CITY OF GOODLETTSVILLE PLANNING COMMISSION

CITY OF GOODLETTSVILLE PLANNING COMMISSION

STAFF AGENDA REPORT

Monday May 6, 2024 5:00 PM

The property is located within the Madison Plan Area. The current land use policy for the property per the City of Goodlettsville Comprehensive Plan is Regional Center High Intensity.

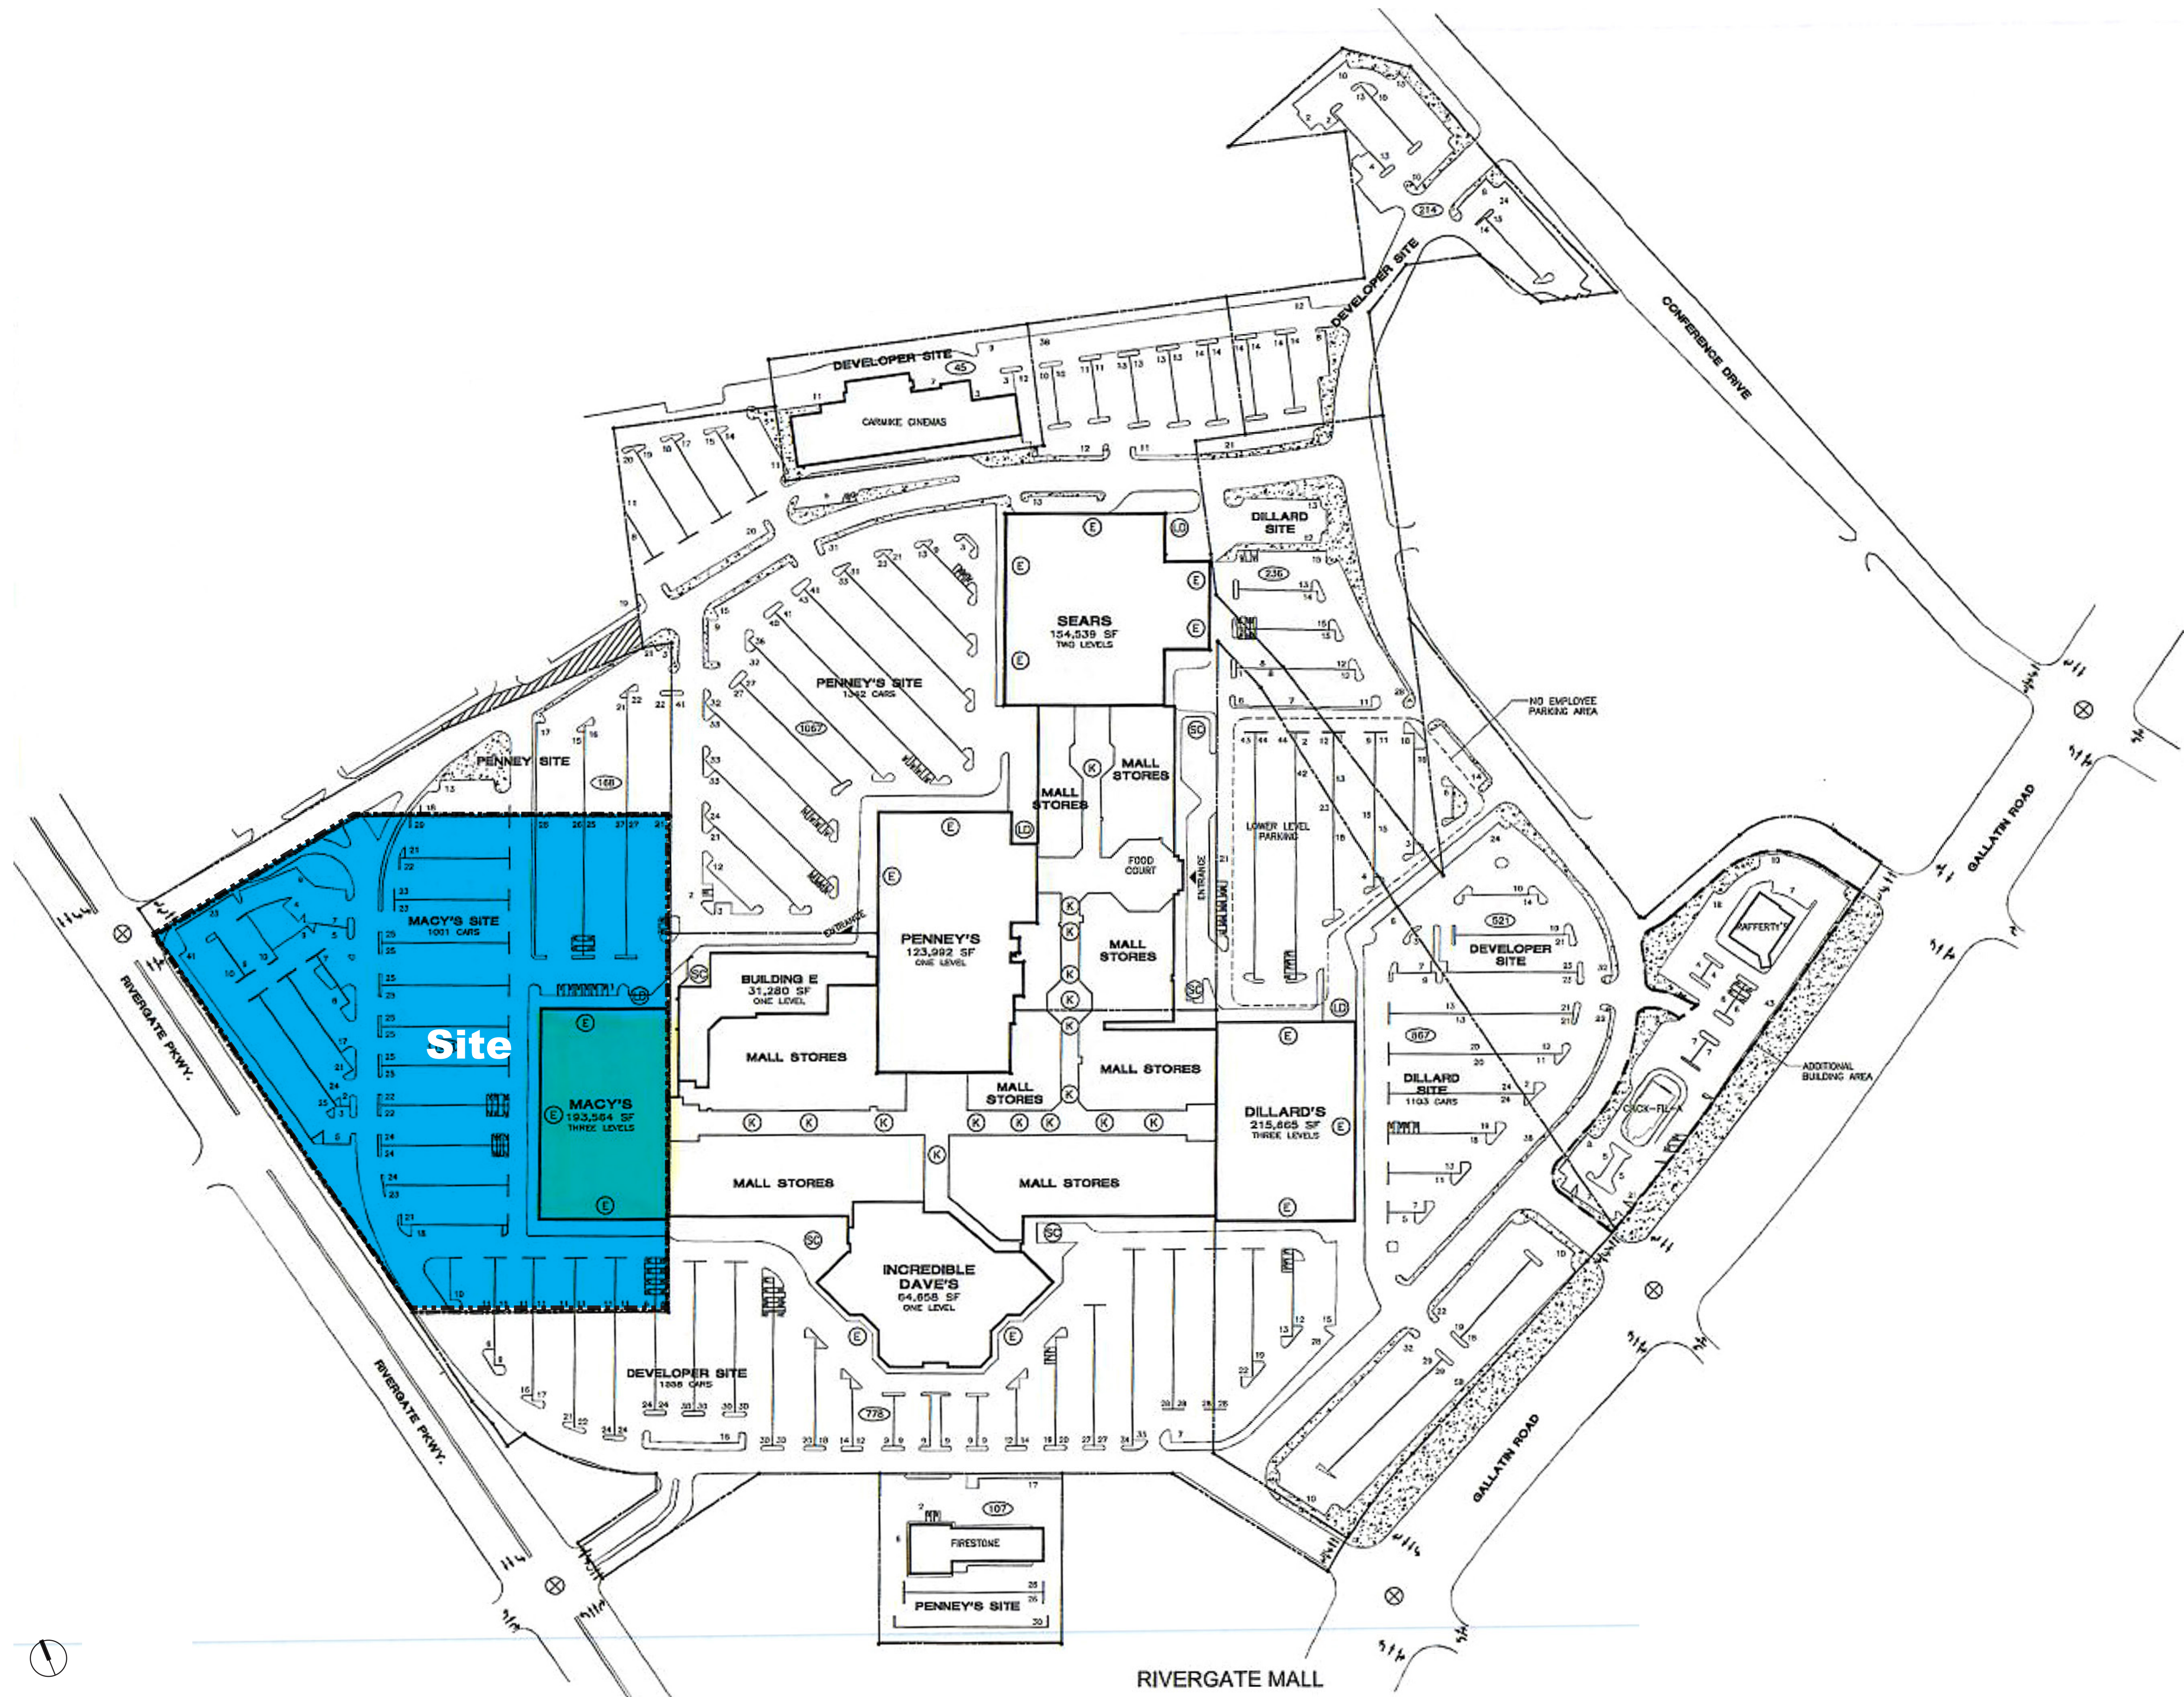
The project includes the demolition of the former Macy's building that is connected to the RiverGate mall building. See the applicant's response to staff plan review comment about the existing mall building connection.

Provide information on proposed/concept exterior design of mall area with building demolition. Existing Macy's Building to be demolished. Existing cmu block demising wall to mall concourse to remain and be stabilized. Infill wall openings with cmu block and repaint the entire wall with a neutral color. Proposed mall building improvements seem appropriate given that Rivergate Mall property is currently listed for sale and the site is a viable location for redevelopment.

The preliminary master plan includes renderings of the proposed buildings. The project designs will be required to meet the City's Design Guidelines. The one level commercial projects will need to be designed to have the appearance of larger height two (2) story buildings to meet the streetscape design intended with Regional Center developments. The building designs could include different design options to for an increased height appearance with a one-story use.

The project proposal includes 340 residential units including 197- one bedroom and 143- two (2) bedroom units. The proposal is for 510 parking spaces/1.5 parking spaces per unit. The City's parking requirement would be 581 parking spaces based on the bedroom unit breakdown. The City has reviewed and approved similar reduced parking requirements for larger scale residential developments in a mixed use setting with preliminary master plan review process.

1. City Fire Marshal and Fire Department requests a twenty-six (26') feet width access drive provided from private Rivergate Parkway drive connection between the proposed hotel and commercial building connecting to the twenty-six (26') feet drive behind the proposed buildings adjacent to the existing mall building. Twenty-six (26') feet drive shown as solid red line on plan sheet page thirteen (#13).
2. All building designs including residential buildings, hotel, and commercial outbuildings to meet the City's Design Guidelines. If the preliminary master plan is approved, the building formal designs to be submitted with a final master plan process including materials and color requirements.
3. Commercial outbuildings to be designed to meet streetscape design increased building height similar to a two (2) story building. If the preliminary master plan is

- approved the commercial outbuilding designs to be submitted with the final master plan process including materials and color requirements and designs to be similar to the building height of two (2) story buildings.
4. Adjacent mall building and parking designs. If preliminary master plan is approved the design of the revised mall building exterior design and disconnected adjacent parking lot connections to be finalized including written letter from the adjacent property owners. The intention is for the usability of the adjacent mall building and adjacent parking spaces next to the disconnected project parking boundary.
 5. Rivergate Parkway traffic signal and turn lane review. If preliminary master plan is approved, provide with final master plan a traffic study to determine any traffic signal or turn lane alterations needed
